**BOWERS ELEMENTARY SCHOOL
MANCHESTER, CONNECTICUT
STATE PROJECT NO. 077-0239 RNV
ADDENDUM NO. 7
March 2, 2022**

I. REVISIONS TO SPECIFICATIONS

11.1

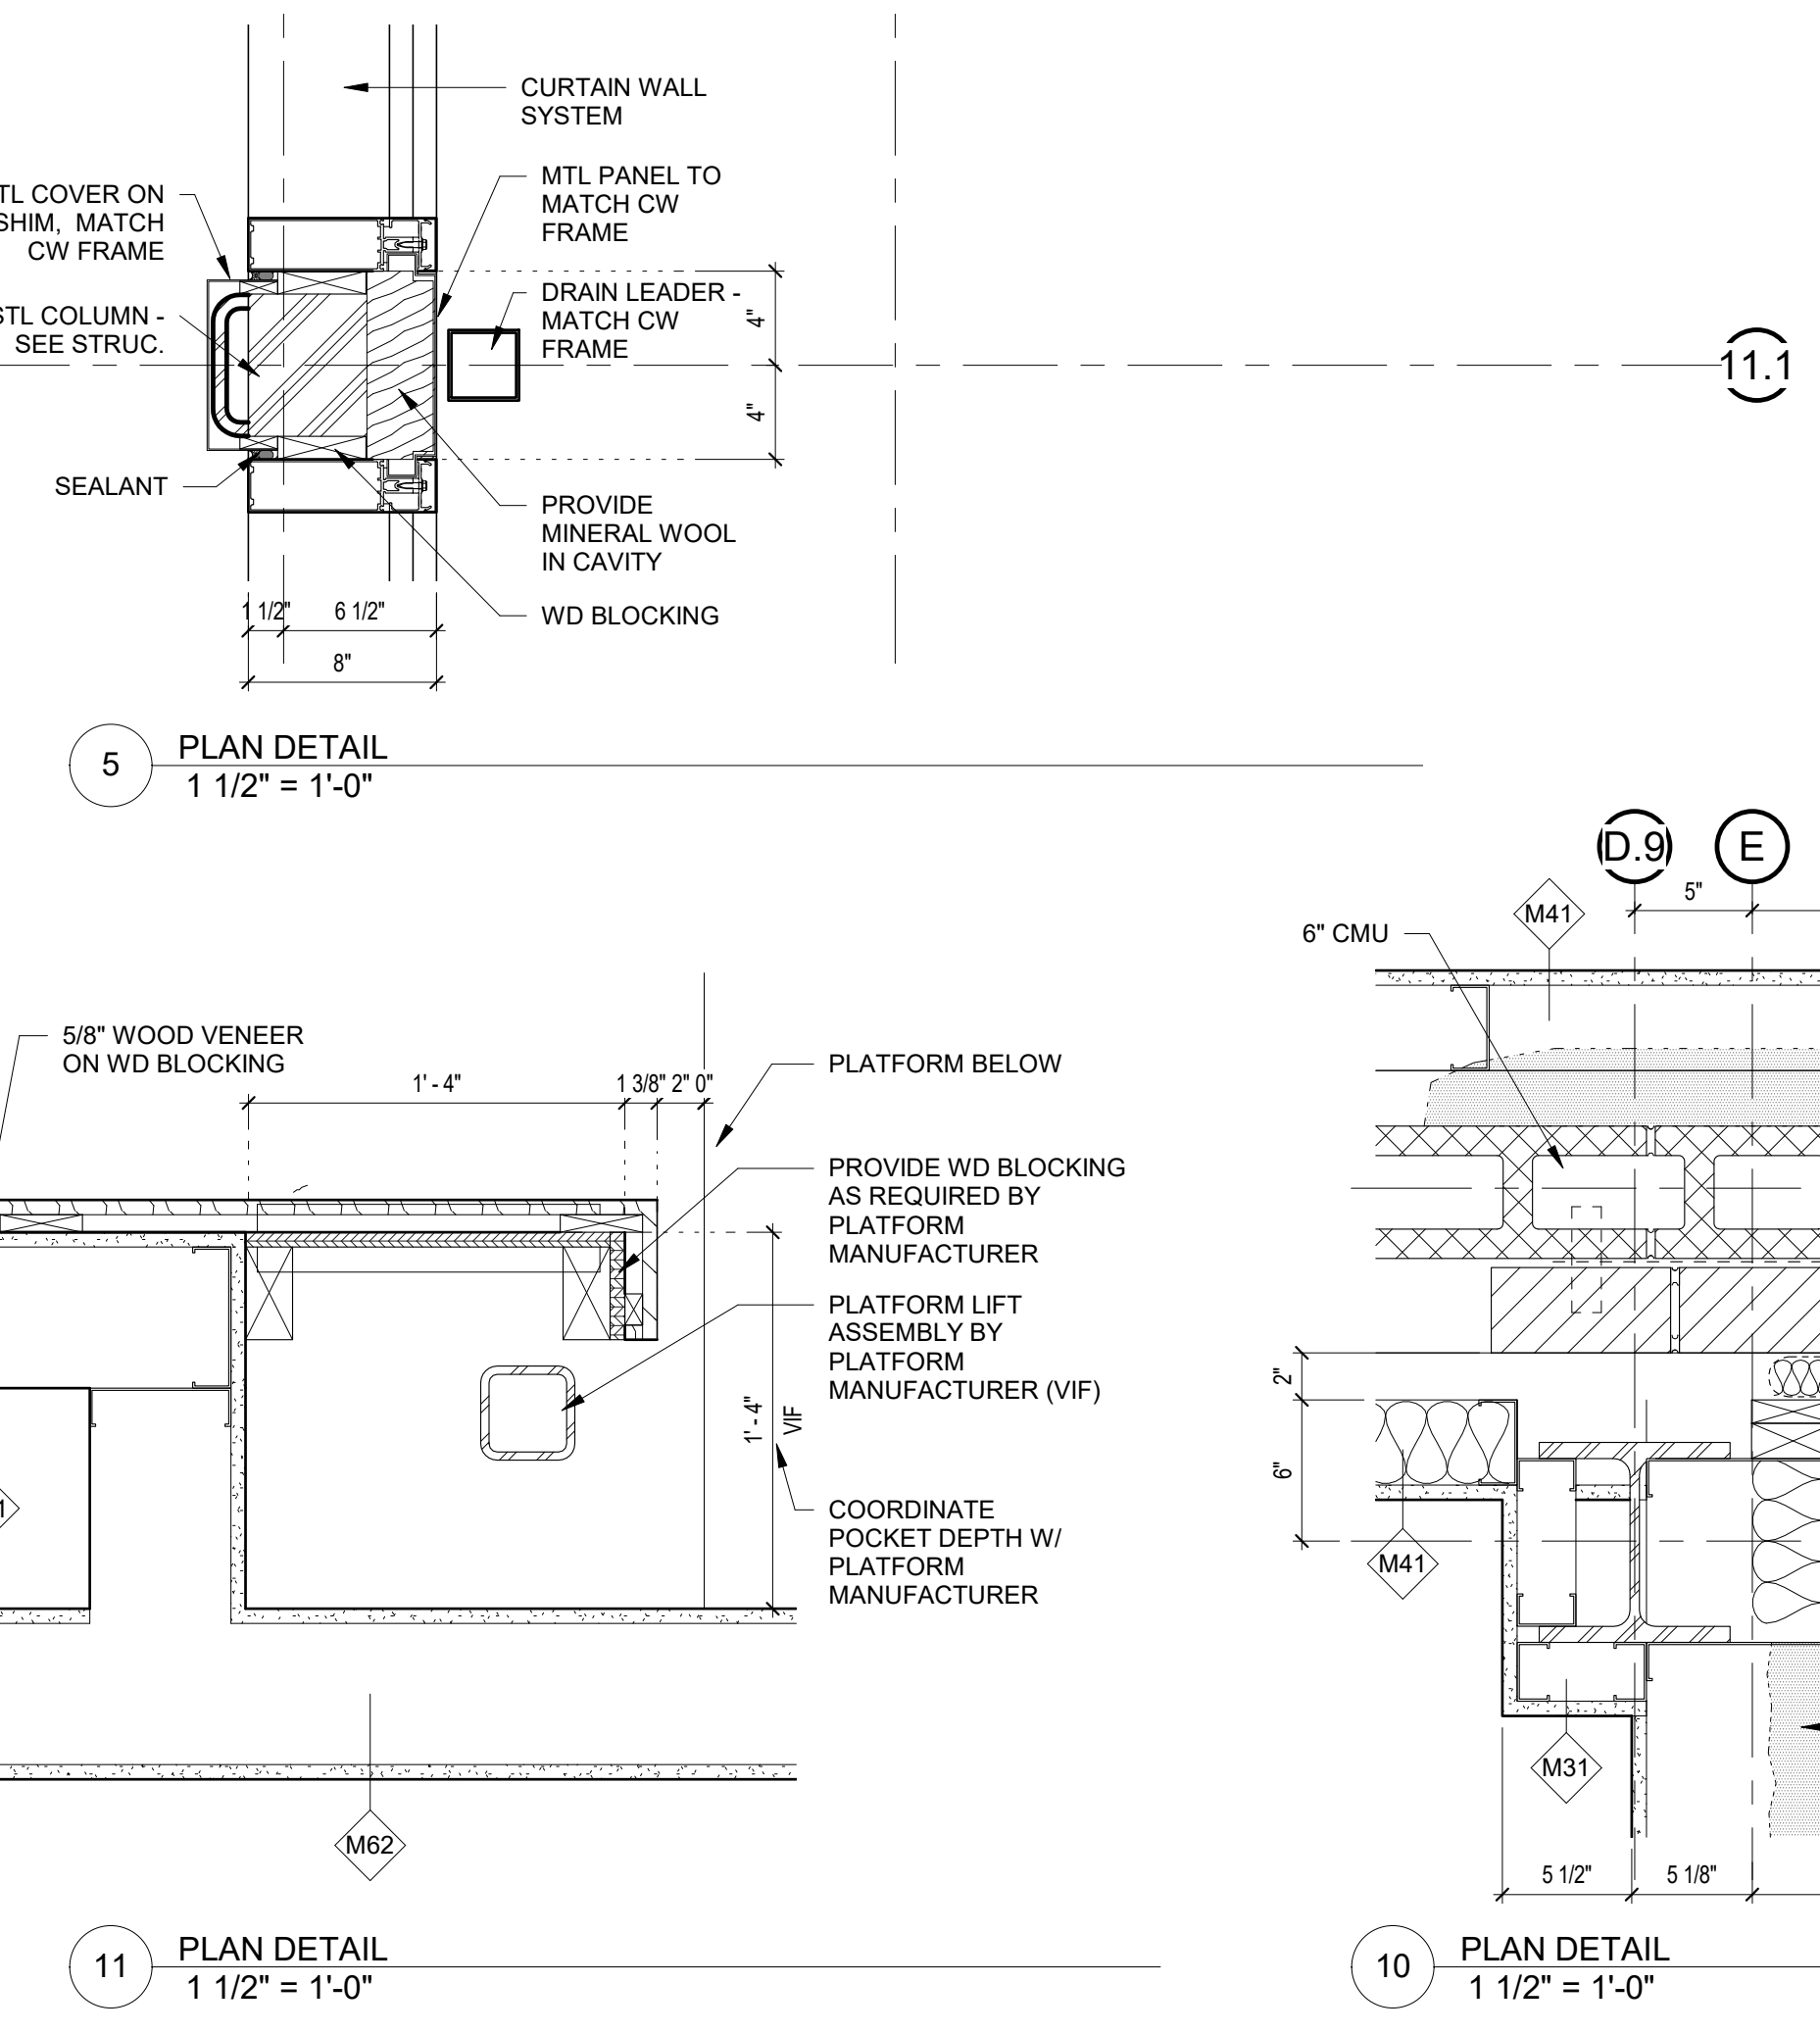
7. A4.01;
- Replace sheet with attached A4.01.
8. A4.21;
- Replace sheet with attached A4.21.
9. A4.22
- Detail 4; Refer to revised sketch PB_SKA-05R
10. A4.24
- Detail 2; Refer to revised sketch PB_SKA-05R
11. A4.31;
- Replace sheet with attached A4.31.

PARTIAL ELEVATION AT WEST ENTRANCE
SCALE: NTS, REFERENCE SHEET: 8/A3.03

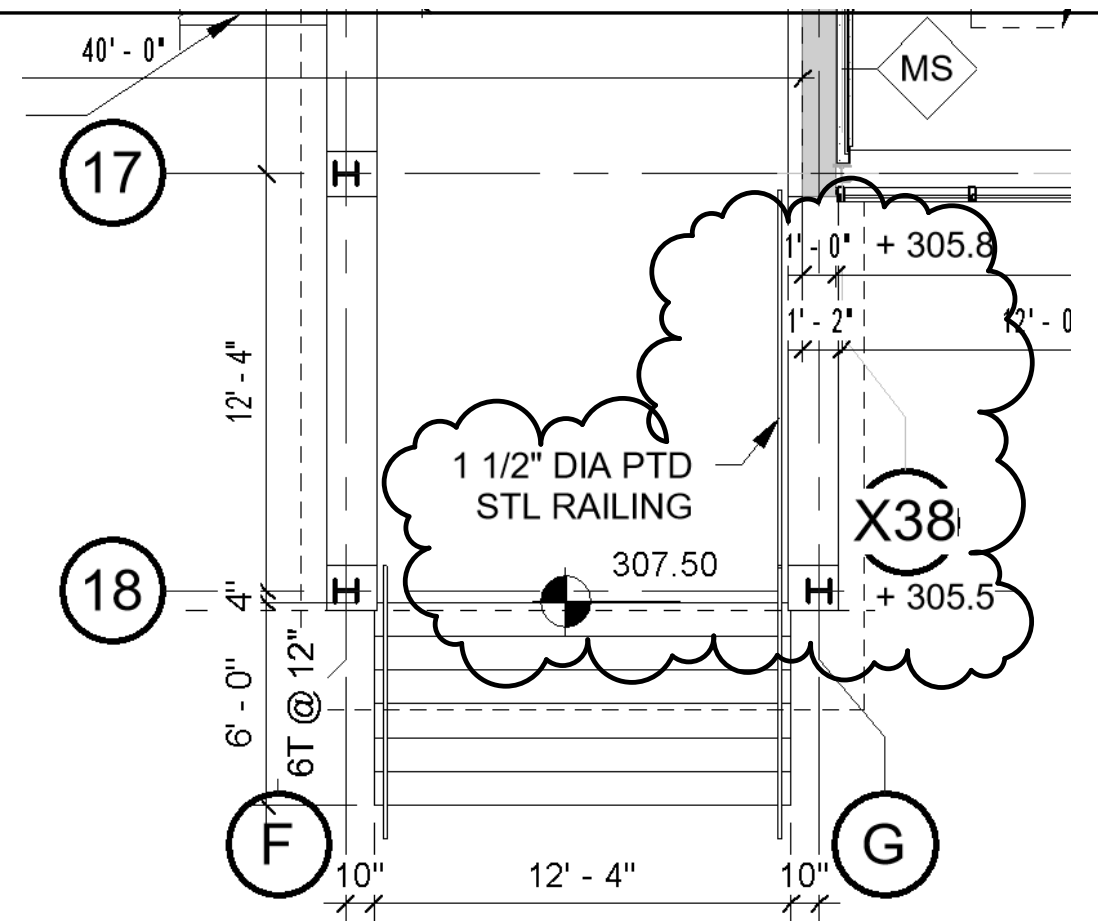
3. A1.01B:
 - Extend railing along north wall of east entrance stair as shown on sketch PB_SKA-09.
4. A3.02;
 - Replace sheet with attached A3.02.
5. A3.03
 - Elevation 8; Revise per PB_SKA-09.
6. A3.11
 - Section 2; Revise per PB_SKA-09.
